TECHNICAL NOTE

Date: 24 March 2022
To: Craig Burden – Redrow – Head of Planning
Pete Hodgson – Redrow – Planner
From: Stefan Kowalczyk – RPS – Senior Arb Consultant
Pages: 7 inc. this page
Regarding: Tree Protection Fencing at Camp Field, Havant

Inspection of Tree Protection Fencing at Camp Field, Havant

Figure 3. Snapshot of approved Tree Protection Plan existing, approved & proposed TPF location

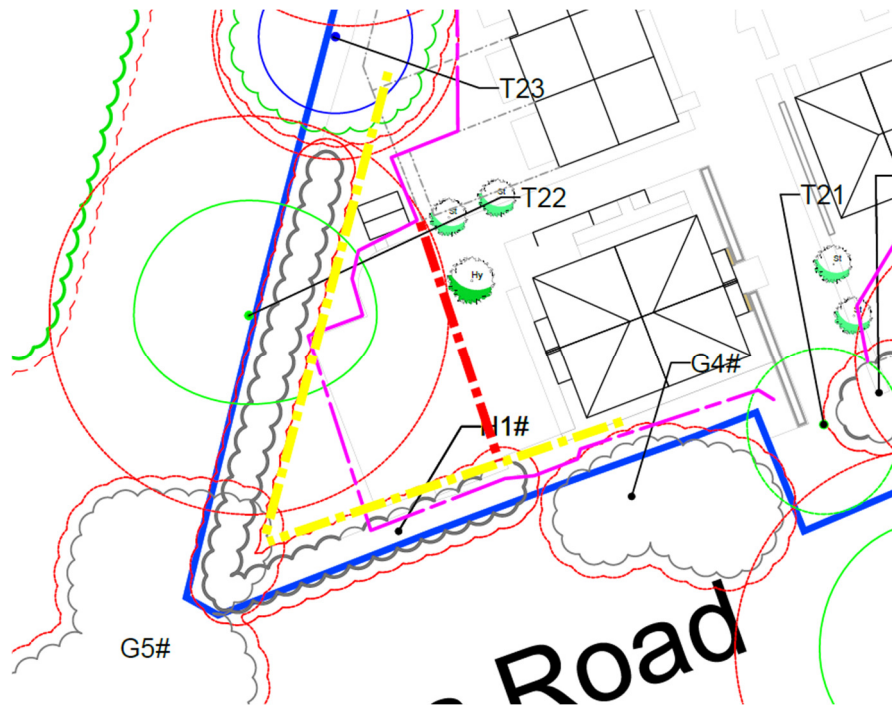
G4# and H1# is a continuation of the southern boundary tree line and is of no particular merit. T22, Oak, on the other hand is a high-quality tree with a large RPA located on the western boundary. TPF is currently positioned incorrectly.

- 1) Yellow (dash dot) line represents the current location of TPF.
- 2) Pink/Magenta (dash dot) line represents the approved location of TPF.
- 3) Red (dash dot) line represents the proposed line of TPF.

Furthermore, a pilling mat of hardcore has been laid within the area marked by the red line. This seems to be unnecessary due to the large distance between the pilling mat in this area and any proposed building foundation.

- 1) Present question to construction asking whether the pilling mat can be removed from the area within the red line.
- 2) Re-instate TPF to the red line at best or pink/magenta lines at least.

Figure 5. Tree Protection Plan showing trees along western boundary

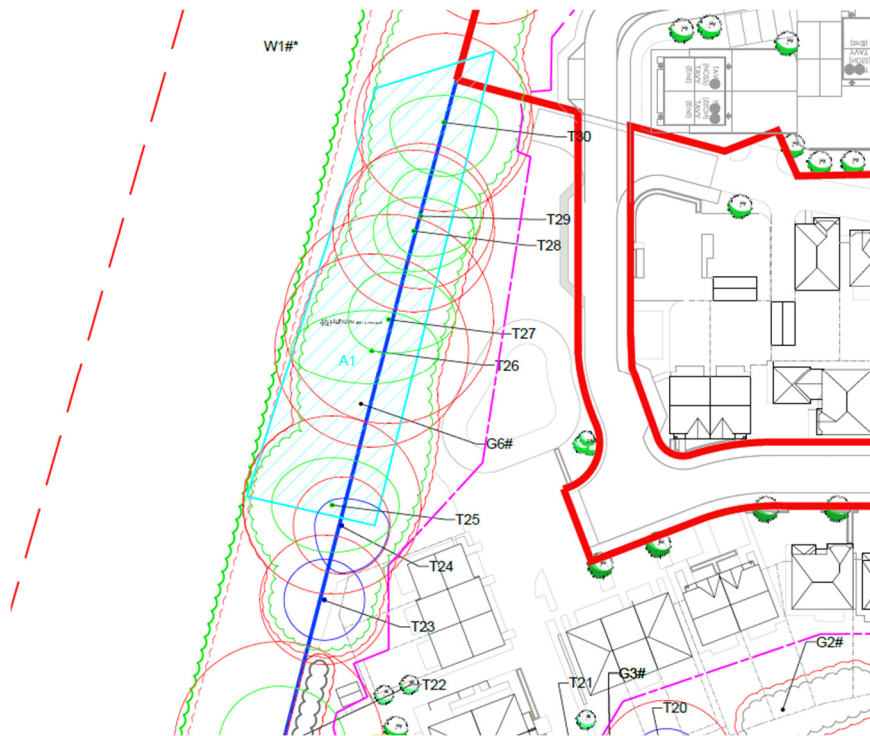
The western boundary is populated by large, mature Oak trees that are protect by a Tree Preservation Order (TPO) administered by Havant Borough Council.

TPF is currently located well within the approved location as described on the Tree Protection Plan i.e., the TPF protects far less area than approved. There is an existing ditch within the RPA on the eastern side of the stem which may limit shallow rooting to the east somewhat. However, given the age and stature of these trees it is highly likely that roots have occupied the land east of the exiting ditch.

Topsoil within the RPA has been removed back to the existing fencing line. Fortunately, there were no obvious signs of exposed roots. However, as above, it is likely that the roots have established in the sub-soil outside of the current location of the TPF.

It is noted that a below ground attenuation tank is proposed in this area, the north-western corner of which protrudes significantly into RPA plus, reinforcing batter which will likely extent up to or close to the tree stem of T28 & T29 – there's a **high risk** of potentially damaging structural root systems and destabilising large mature Oak trees.

There's also a **high risk** in terms of tree protection fencing being in the wrong location around TPO'ed boundary trees. Similarly, topsoil has been removed within RPA. Note: The TPO legally protects all parts of the tree, even those parts which are below ground.

- 1) Present question to construction of whether firstly, the location of the tank can be altered to avoid RPA. Secondly (and perhaps more realistically) raise the question of using a sheet pile type reinforcement to avoid the requirement of batter/excavation up to/close to stems of TPO'd trees.

- 2) Retain TPF in its current location in order to install below ground attenuation tank and attenuation basin but, re-instate topsoil and fencing in areas that don't restrict construction.
- 3) If the traditional batter back cannot be altered to less intrusive method, ensure excavation within RPAs is overseen by an Arboricultural Consultant to ensure any evidence of root severance is documented. Collected information can be used to inform any mitigating measures required such as crown/weight reduction works to the canopy or, removal of the tree due to extensive root severance or, no works.
